Access Compliance Report

Public Rights-of-Way

Intersection ID: 14431	Main Street: RANDOLPH_RD	Cross Street: COLONIAL_DR	Location: S
ADA ID: A1E4CAEEA521	Ramp Type: PerpDiag	Initial Pass/Fail: Fail	Overall Compliance: No
		Severity Score: 12.5

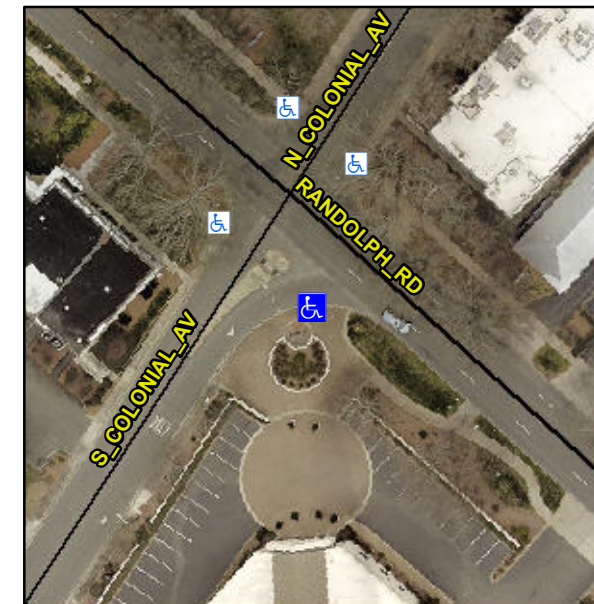
Not Found, R304.2.2

Compliance	Description	Data	Compliance	Description	Data
N/A	Ramp Length (in)	60.0	No	Ramp Slope (%)	9.1
Yes	Ramp Width (in)	48.0	Yes	Ramp XSlope (%)	0.5
N/A	Flare Type LT	N/A	N/A	Flare Type RT	N/A
N/A	Flare Slope LT (%)	N/A	N/A	Flare Slope RT (%)	N/A
N/A	Flare Traversable LT?	N/A	N/A	Flare Traversable RT?	N/A
N/A	Landing Length (in)	N/A	N/A	DWS Provided?	N/A
N/A	Landing Width (in)	N/A	N/A	DWS Contrast?	N/A
N/A	Landing Slope (%)	N/A	N/A	DWS Length (in)	N/A
N/A	Landing X Slope (%)	N/A	N/A	DWS Full Width?	N/A
N/A	Landing Curb? (Y/N)	N/A	N/A	DWS Offset (in)	N/A
N/A	Shared Landing?	N/A			
N/A	Gutter Ponding?	N/A	N/A	Gutter Slope (%)	N/A
N/A	Gutter Lip Ht (in)	N/A	N/A	Gutter X Slope (%)	N/A
N/A	Painted X Walk1?	No	N/A	Painted X Walk2?	No
	X Walk 1 Direction	To NE		X Walk 2 Direction	To NW
N/A	X Walk 1 Width (in)	N/A	N/A	X Walk 2 Width (in)	N/A
	X Walk 1 Slope (%)	0.1		X Walk 2 Slope (%)	0.3
	X Walk 1 X Slope (%)	2.3		X Walk 2 X Slope (%)	0.1

Remove & Replace Curb Ramp With Two New Directional Ramps or Equivalent.
